**43 Drewry Avenue – Rezoning and Site Plan Control Applications – Final Report**

<b>Date:</b>	May 2, 2011
<b>To:</b>	North York Community Council
<b>From:</b>	Director, Community Planning, North York District
<b>Wards:</b>	Ward 23 – Willowdale
<b>Reference Number:</b>	08 215402 NNY 23 OZ and 10 279594 NNY 23 SA

# Attachment 1: Site Plan

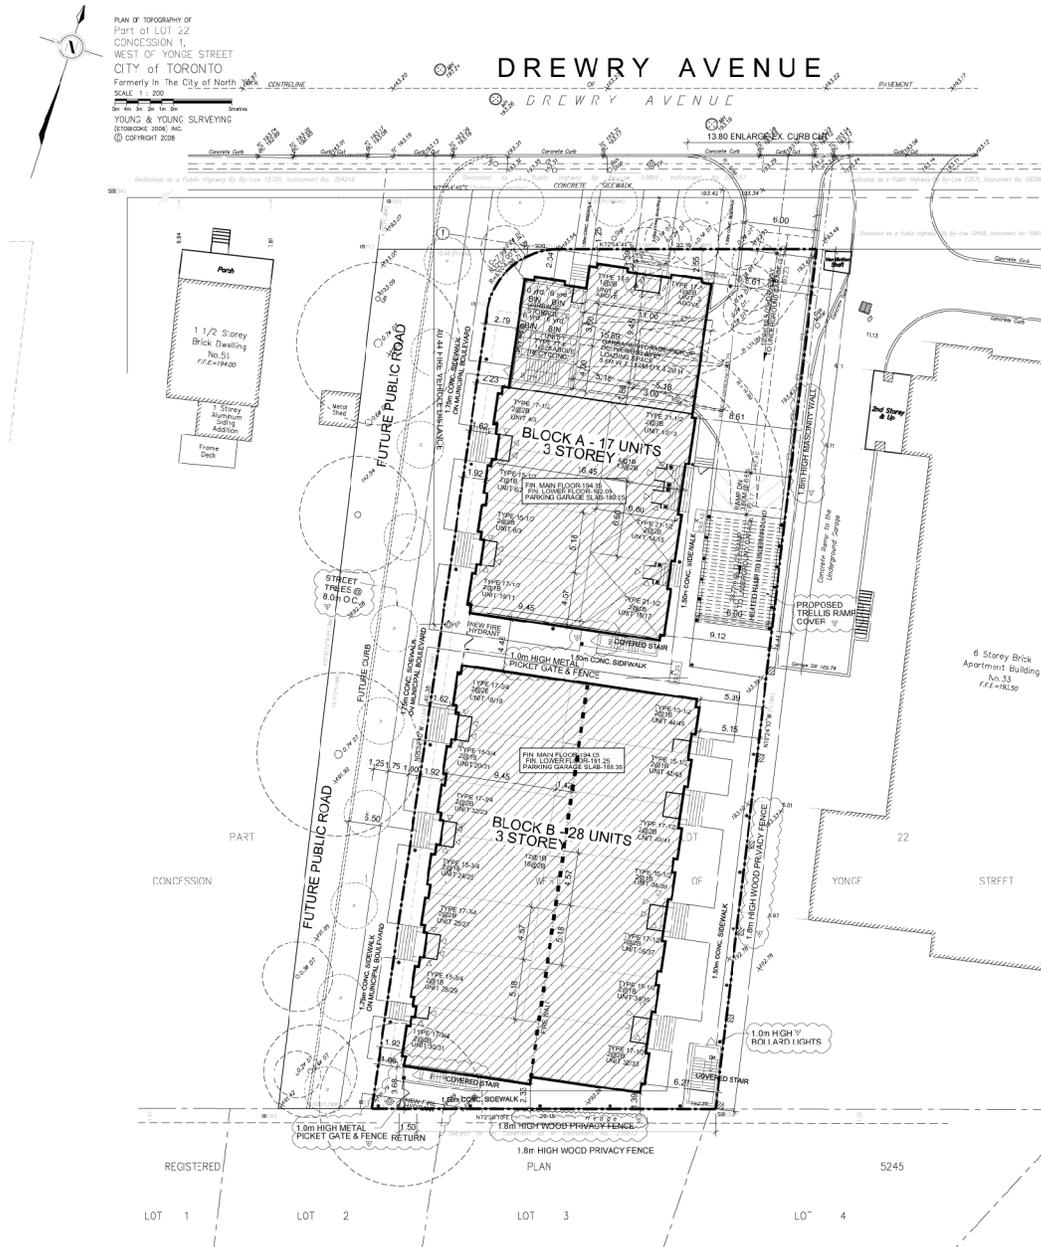
Staff have reviewed the site plan control drawings and require some modifications to the plans prior to final site plan approval that include: incorporating planting material on the trellis over the parking garage; lighting details; improving the treatment of the wall on the south side of 'Block B'; and matters within this report discussed relating to servicing and heritage preservation.

10. Revise the plans and drawings as follows:
  - a. Revise the Site Plan illustrating that for buildings without interior access between separate units, the distance from the fire vehicle to one entrance of each unit of the building shall be no more than 45 metres.
  - b. Revise Site Plan in accordance with By-Law No. 235-2001, Waste Collection, Residential Properties, of the City of Toronto Municipal Code, and meet the guidelines of the “City of Toronto Requirements for Garbage and Recycling Collection for new Developments and Redevelopments”.

- c. Revise the Site Plan to show the location of the Garbage Room and Compaction Unit as the garbage generated from the development must be mechanically compacted.

- d. Revise the Site Plan to indicate which waste diversion system for multiple household residential buildings will be used with one of the methods outlined below.

**Attachment 2B: Elevations Block B**

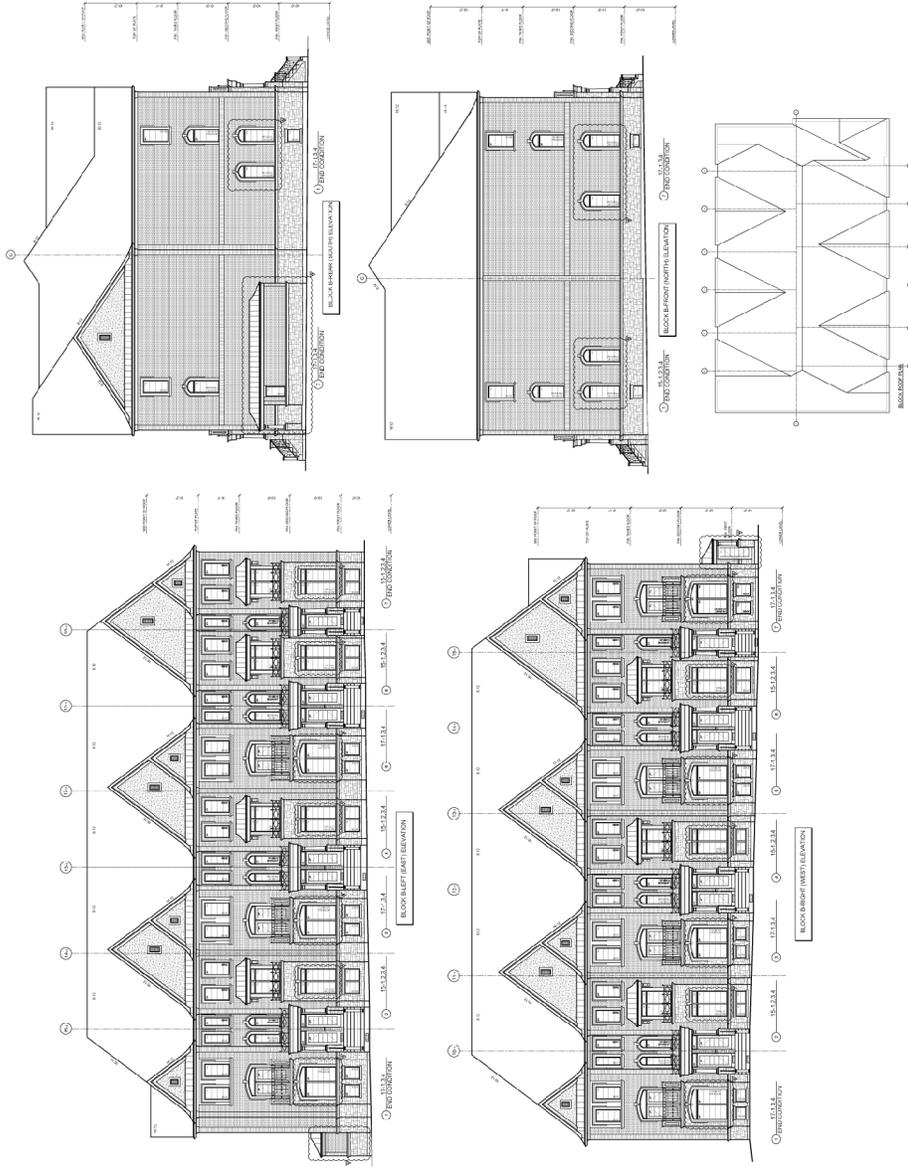
2. Revise the plans and drawings as follows:
  - a. Block B Block Elevations (A6) to provide more windows and improved treatment for the south wall of Block B.
  - b. Site Plan and Landscape Plan L.1 to provide a detail/elevation of southeast corner stair area. Detail should include glazing and illumination information.
  - c. Site Plan to remove fire hydrant located in the middle of the walkway in between the two blocks.
  - d. Site Plan to include a detail indicating where the transformer is to be located.
  - e. Site Plan and Landscaping Plan L.1 to illustrate the retaining wall along the east property line extending to the Drewry property line in order to screen the garbage area.
